In the Matter of
SEQUOYAH FUELS CORPORATION
Docket No. 40-8027-MLA-3

RE: License SUB-1010; Docket No. 40-8027
Revision to Amendment Application - Organization

RESPONSES TO COMMENTS ON
PROPOSED LICENSE AMENDMENT
FOR SFC ORGANIZATION

Figure 2-1

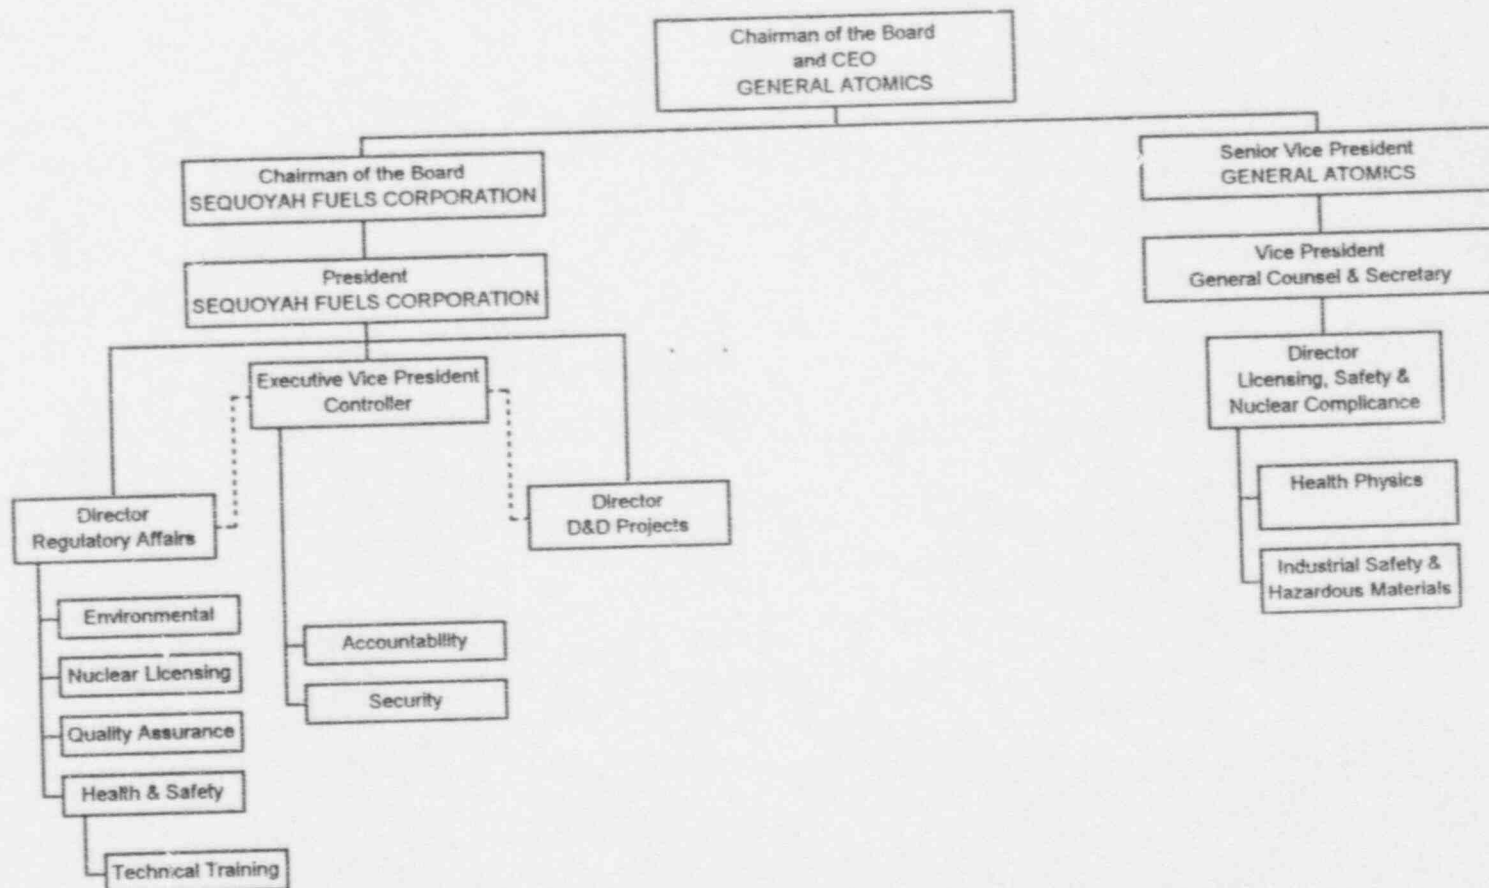
10. The Technical Support Department is not identified on the organization chart submitted with this request (Figs 2-1 and 11-1). Because it is assigned a safety related function, it should be identified along with the reporting chain.

SFC does not fully concur with this since the Manager, Project Technical Support and his reporting chain are shown on Figures 2-1

and 11-1, as submitted on May 6, 1994. However, the functions of the Manager, Project Technical Support are part of the responsibilities of the Decontamination and Decommissioning Division. Accordingly, Sections 2.7.4 and 2.7.5 and Figures 2-1 and 11-1 have been revised to eliminate references to the Technical Support Department or Manager, Technical Support.
